Barnali Collections Ltd

20 November 2023

Structural Inspection Report

Observation-1: Boundary wall leaned south side of Building 1 (Production Building)

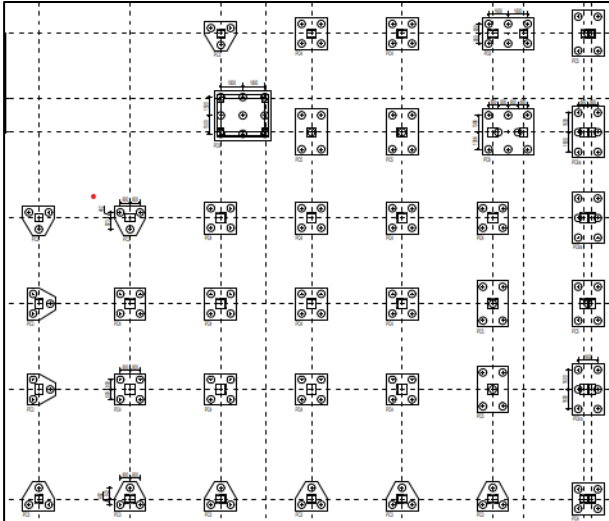
Leaned Boundary wall

Earthwork ongoing opposite of the wall

Description: During the inspection, a portion of the boundary wall was found leaning toward the factory premises on the south side of Building 1 (Production Building). Earthwork is ongoing on the far side of the boundary wall. The boundary wall is potential to hazard.

Observation	Action Plan	Timeline
Boundary wall leaned south side of Building 1 (Production Building)	The factory is required to immediately restrict the entry to the south side set back of the building and provide necessary support to the deflected walls to avoid potential collapse.	Immediate
	The factory is required to demolish the deflected/damaged portion of the boundary wall. During the demolition work, the factory is required to follow standard safety practice as per BNBC.	within 6 weeks
	Further new construction of the boundary wall should be properly designed and supervised by a qualified structural engineer.	within 6 months
Lack of design documents (Building 1 - Production Building).	Verify in situ concrete strength (100mm dia. cores from 4 columns) from lower tier of the building.	within 6 weeks
	The building engineer is required to prepare a set of design documents including as built drawings and a design report based on in-situ material strength and software-based analysis which shall be prepared in compliance with section 1.9.1, part-6 of BNBC.	within 6 weeks
